Fig 1 Lupine Field, lots 131-137 Robert Hale

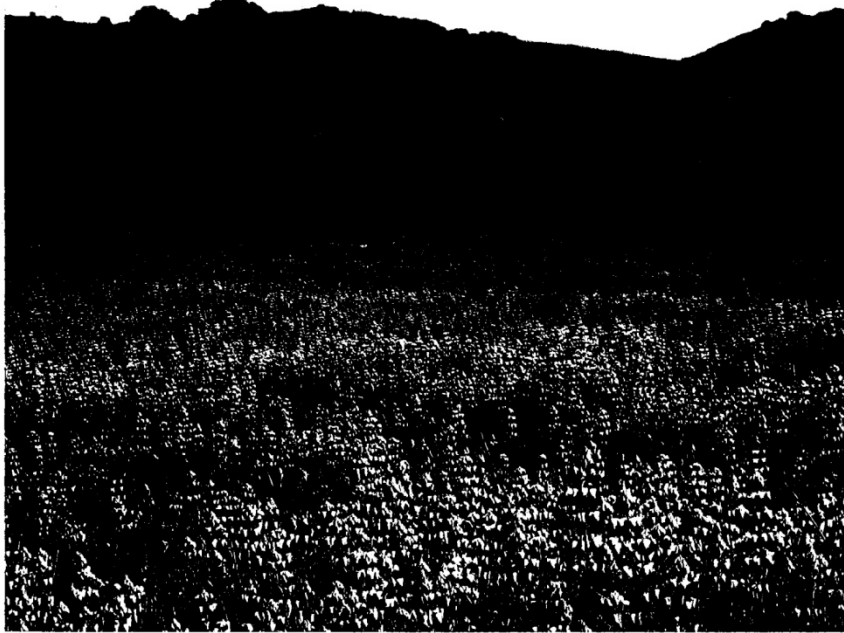
2) **DEIR does not recognize a particularly dense sky lupine field** that borders on the western boundary of Toro Park, where the applicant has proposed lots 131-137. **Attached in Figure 1 and 2, are views of this lupine field** during spring of 2009 taken from close to the boundary of Toro Park and the Ferrini ranch subdivision lots (131-137) at the end of Road G. The lupine display can be spectacular; a friend of mine called it the lupine lake. It is highly visible from a Toro Park trail on the western edge across a barbed wire fence. The loss of this field is a significant visual and biological impact that cannot be mitigated. I request that the DEIR consider a revised alternative moving the building lots from this field. The lots could be reconfigured in the proposed development nodes.

3) **Visual impacts 3.1.2** - The DEIR fails to consider the views from a trail in a public park that passes next to Ferrini ranch where close unobstructed views of lots 131-137 at the end of Road G. Explain why a publically used trail does not qualify for being a viewpoint. This field, which is a great lupine field in good years, is quite visible from a hiking road that follows the boundary ridge. These lots need to be moved and reconfigured in the project to protect the scenic resources of Toro Park. Address why this is not a significant and unavoidable visual impact of the project. There is just no buffer between Toro Park and the housing in group 131-137.

Commenter is referred to Master Response 1, response to comment 27-1 and responses to comments 36-4 through 36-1- regarding visibility from the park. Please see Response to Comment 24-1 above regarding views of lupine.
